## **ADDENDUM 1 - RFP 24-052 INDOOR SHOOTING RANGE CLEANING SERVICES**

**MAY 13, 2024**

ENLARGED RANGE 191  
1/4" = 1'-0"

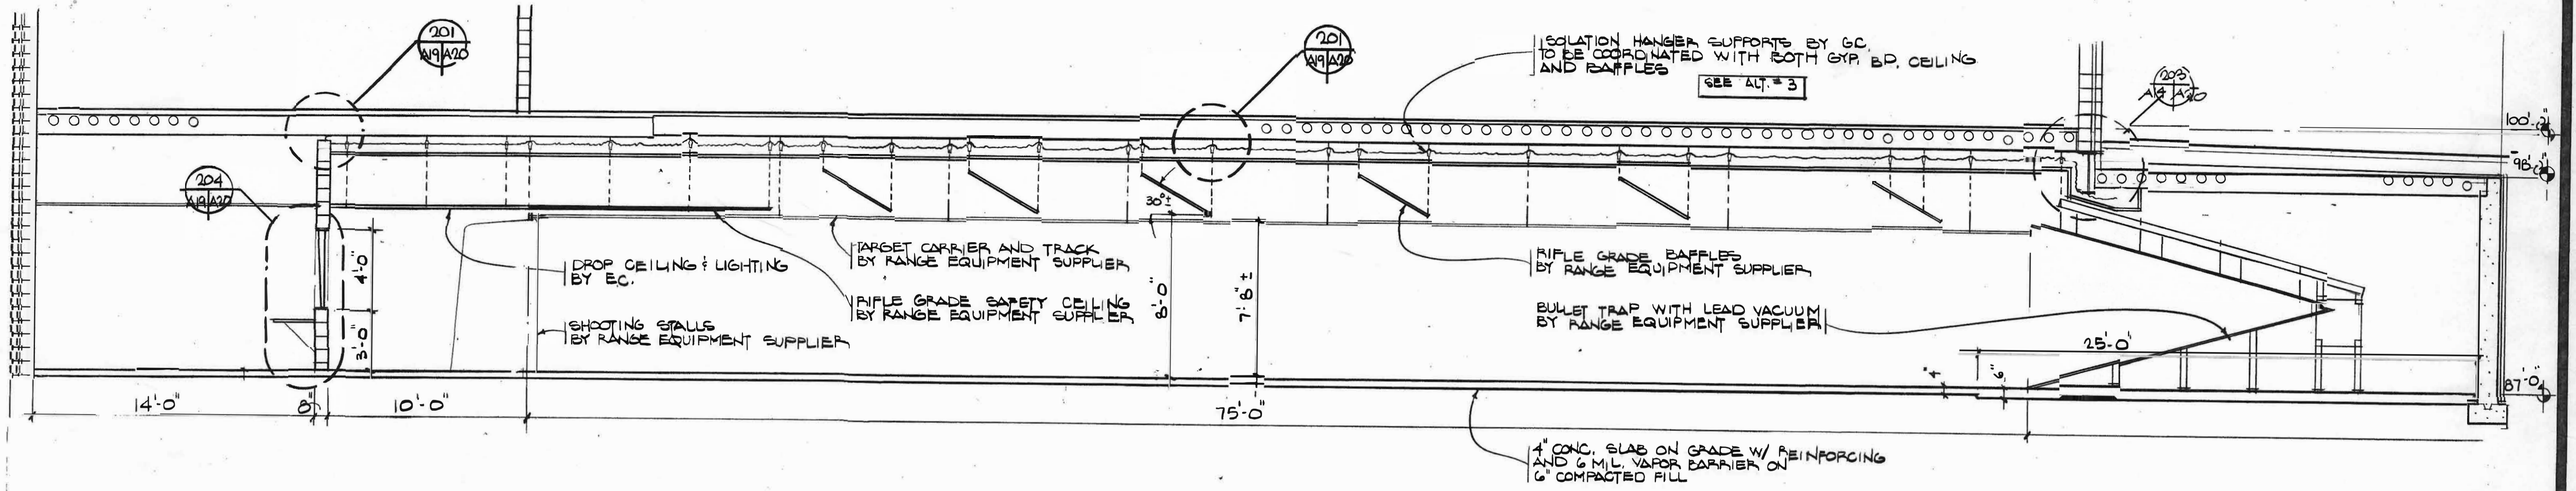
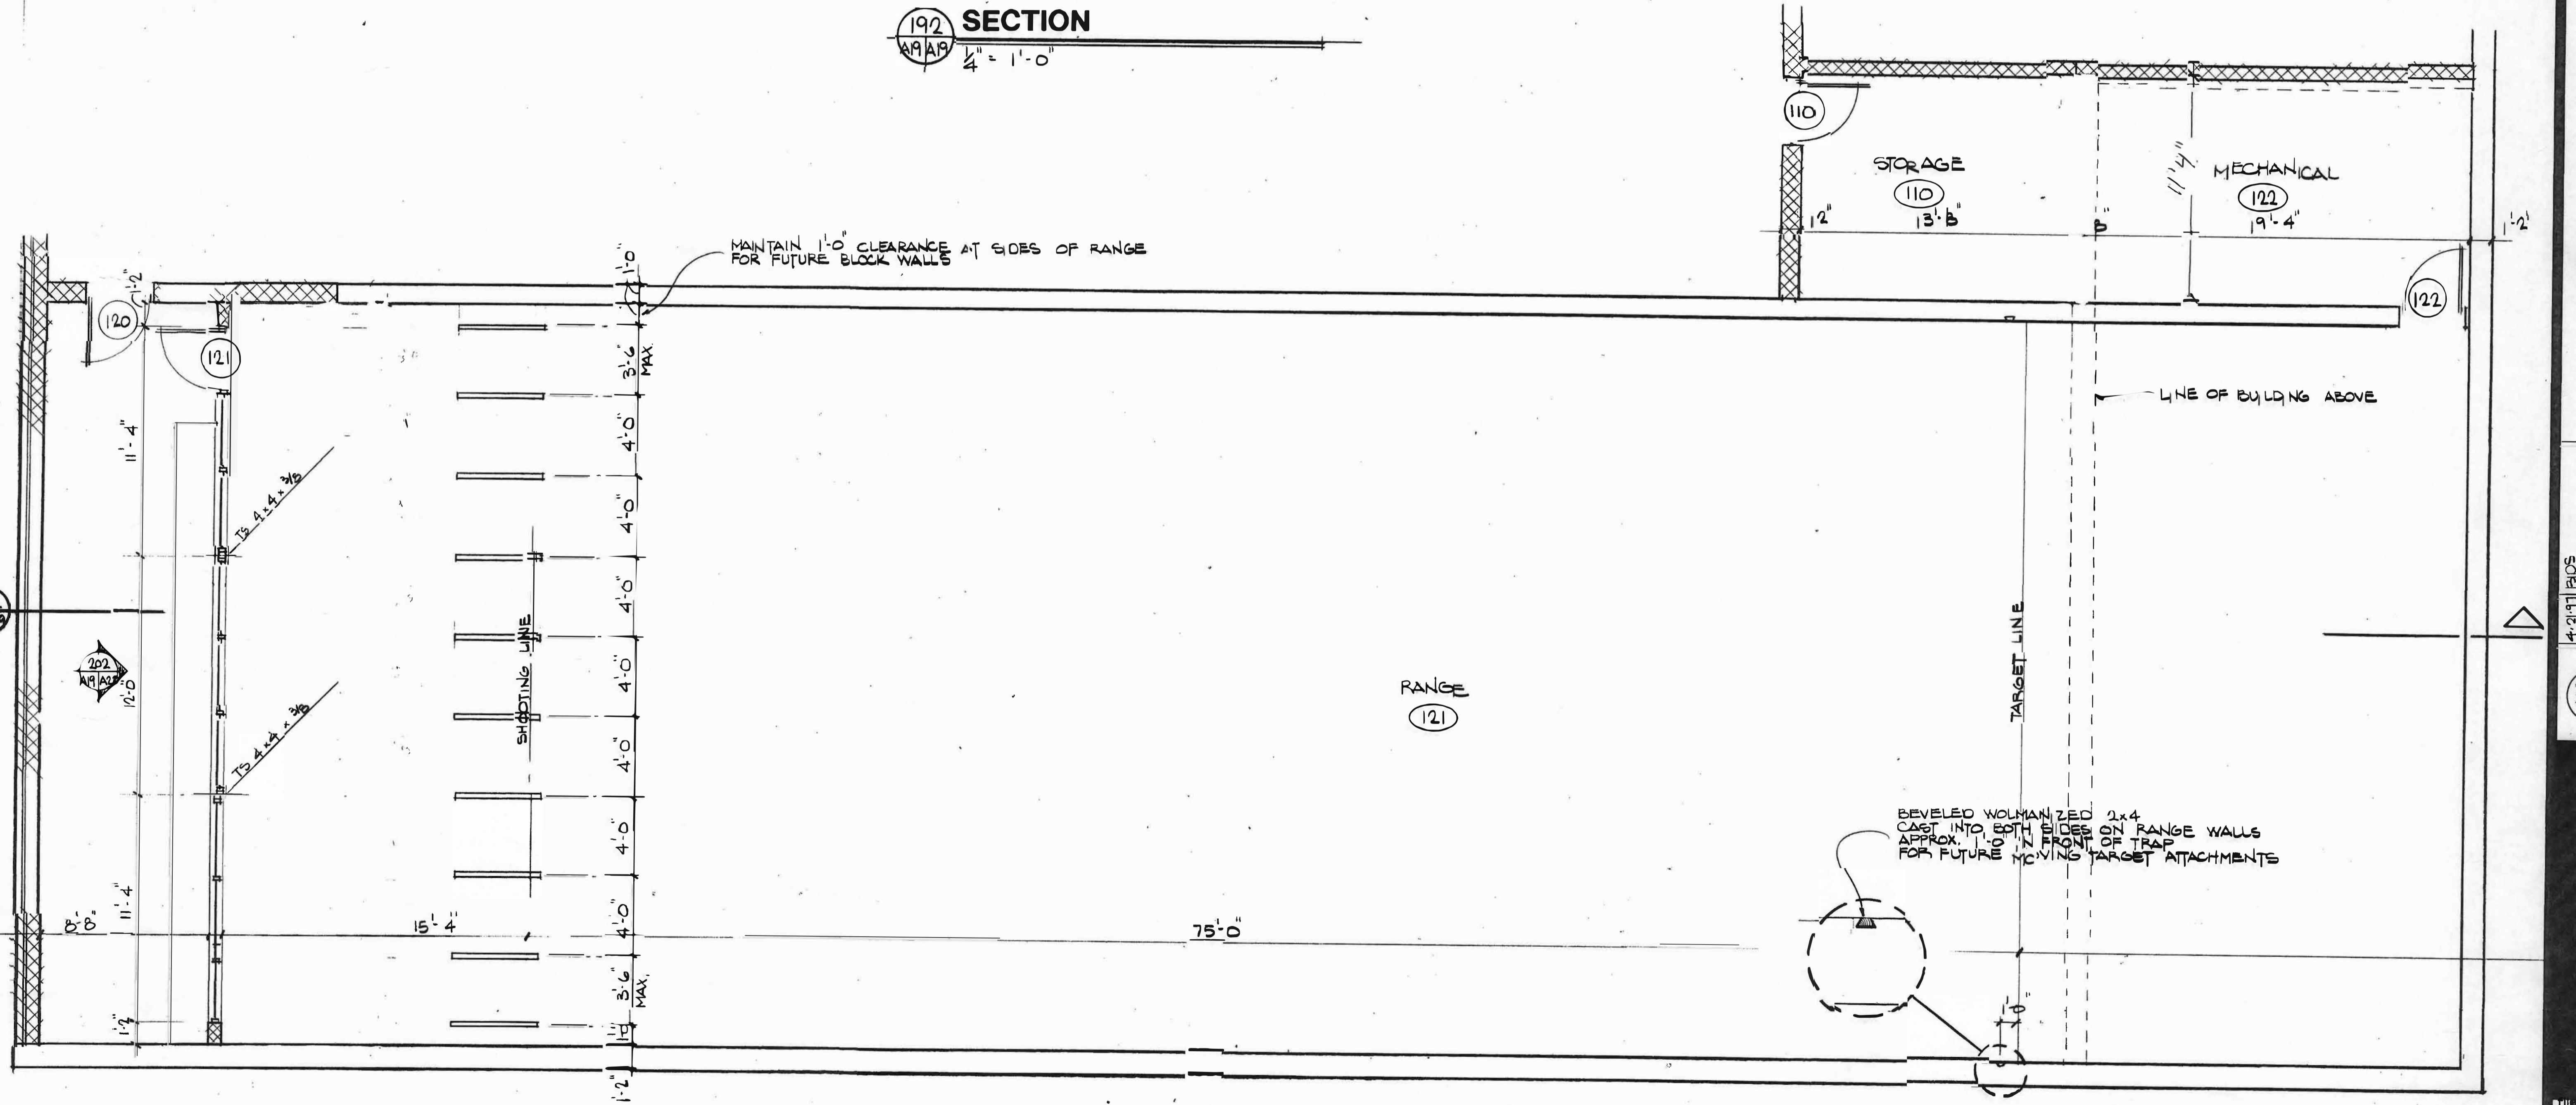
- Q1. What are the dimensions of rooms 110, 121, 122, and 202? How high are the ceilings?
- A1. The size and height of the rooms are on Exhibit 1 – Shooting Range Blueprints, attached.
